# RECALL 24V776 / 2024-614 REMEDY INSTRUCTIONS

<b>FOREST RIVER</b>	Make(s): Collins Bus Model(s): Collins Bus units with IMMI Seats with Latch Bar Installed	Repair Code: RC-045-00-01-004333 Allotted Time: .08 HRS. PER SEAT Inspection Code: N/A Allotted Time: N/A
	Model Year(s): 2023 - 2024 Concern: FMVSS nonconformance	Photo(s) Required: NO Prior Authorization Required: YES Part(s) Kit Number: A117296 Part(s) Return: NO, FIELD DESTROY

Details: Information contained in this document will assist you in removing/installing and torquing IMMI latch bar- child seat tether anchor weldment. Please follow the instructions provided with each picture for details on this repair.

Picture showing IMMI seat Latch Bar and location of the two bolts that need to be removed.

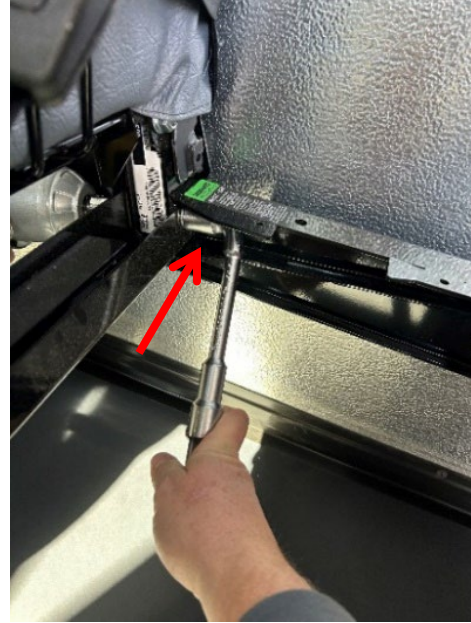
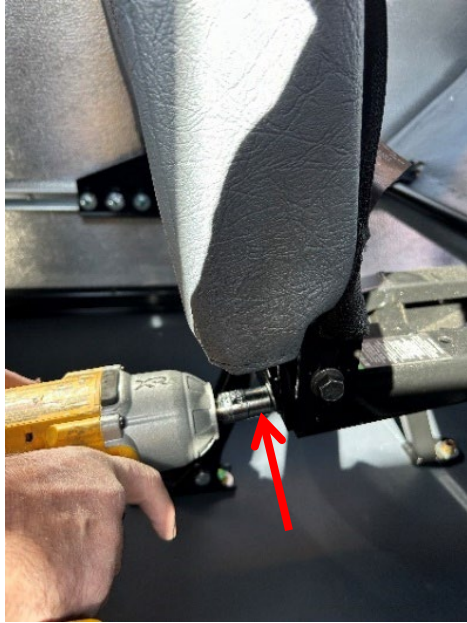
1. Using a 11/16 "wrench and socket remove the bolt/nut completely. Then take the Latch Bar (A116225) off.

2. Put the provided Latch bar (A117296) on the seat rail where you removed the old latch bar. Use the provided 2 bolts ,2 washer and 2 nuts for installing the latch bar. Note: The washer goes between the seat and the latch bar.
